subject: Appeal of the Design Review Board's continuation of SHRA Central Main Facility (DR86-178) for redesign.

SHRA CENTRAL SERVICES MAINTENANCE FACILITY

Subject: SHRA Central Main Facility (DR86-178)

PROPOSAL: New construction, 25,000 square foot maintenance facility

SITE PLAN
 1" = 20'

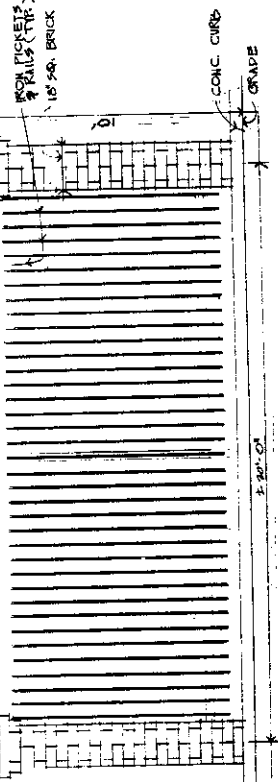
1. The front portion of the project over the office areas should be reduced to one-story in height to be compatible with the other residential structures in the area.
2. Further evaluation of the roof design should be made to make the structure compatible with the Residential Buildings.
3. Provide a hedge at the fence line on the north and south ends of the building facing Muir Way to block the view into the interior yard.
4. Move fence back to face of building facing Muir Way.
5. Provide additional landscaping in the pie shaped area to the west as a buffer to the residential area.

1. Although the office area has not been reduced to one story as requested by the Board, the facade has been changed to give the appearance of a more compatible building to the adjacent residential structures.
2. The roof line had been modified by the addition of multiple gables. This will add interest to the front elevation.
3. The landscaping changes requested by the Board have been made or will be made.

FLOOR PLAN 1/2"=1'-0" 265 FEET

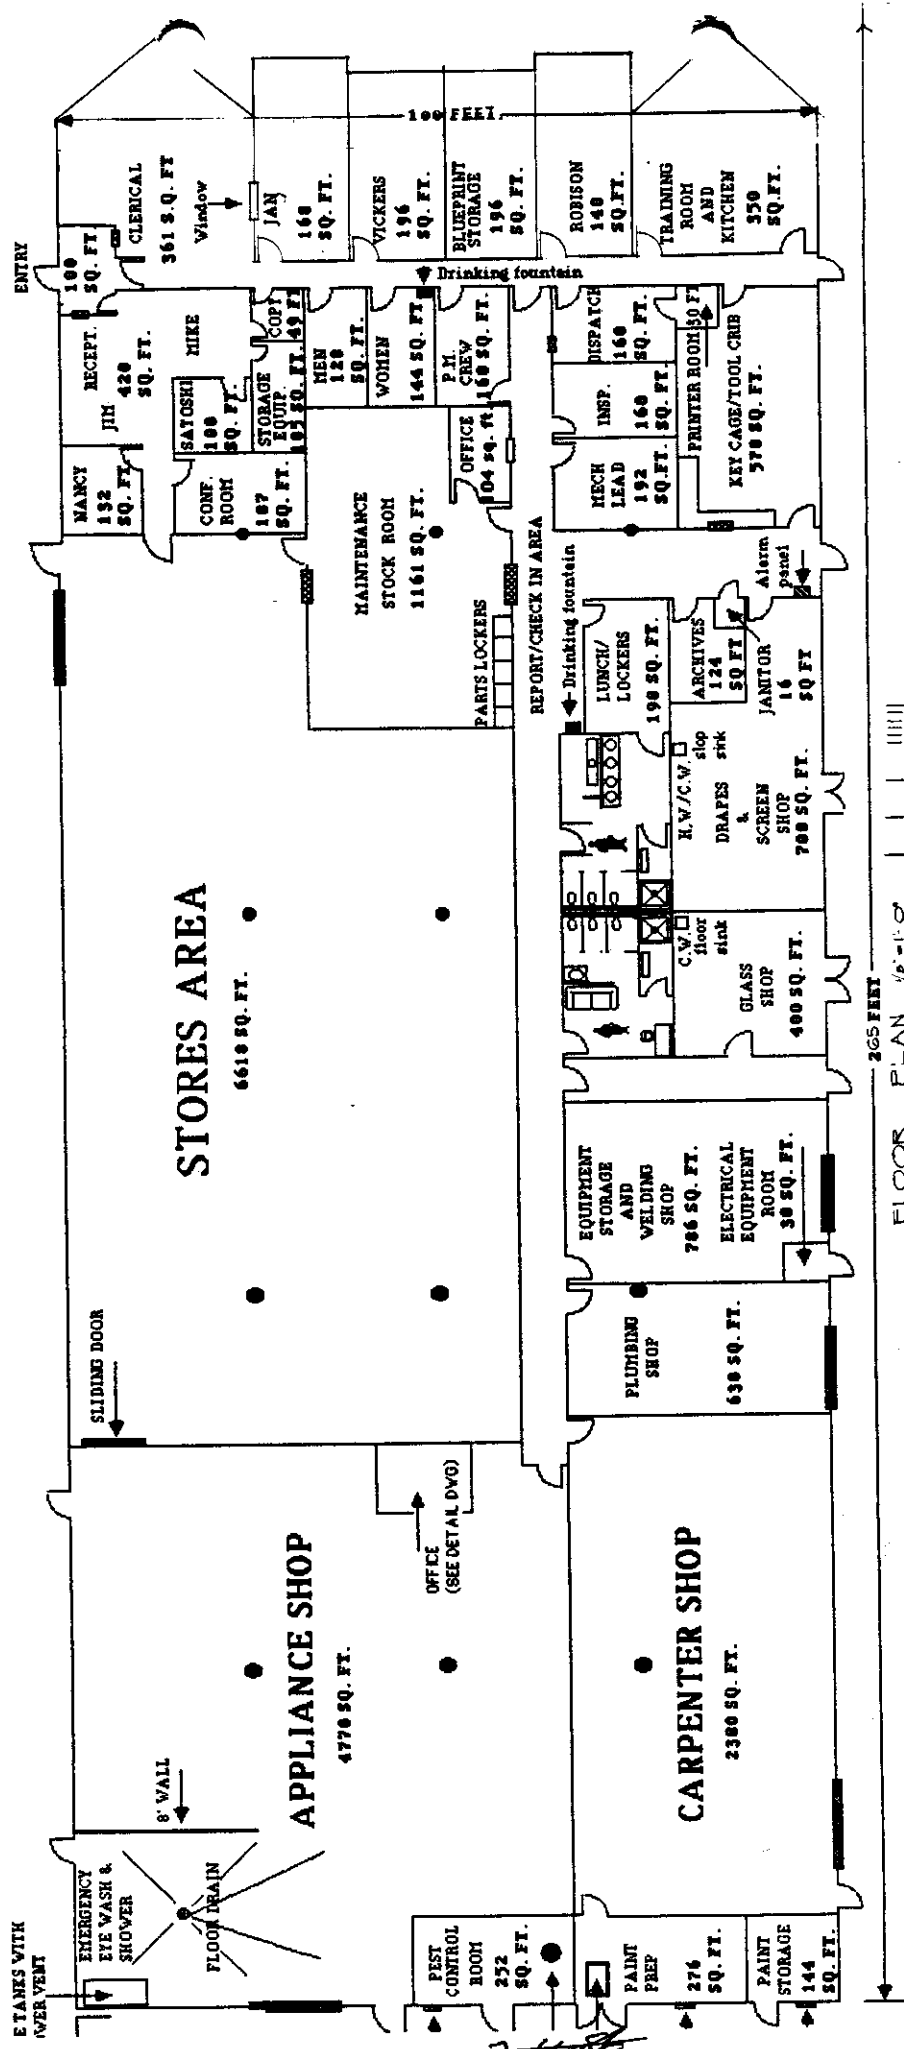
PROJECT EVALUATION: The building complex will have offices across the eastern end of the structure. These offices will have fenestration opening out onto Muir Way. West of the offices the remainder of the building is taken up with storage and shop spaces to be utilized by the maintenance facility. These spaces do not require exterior window openings and most are serviced by exterior doors only.
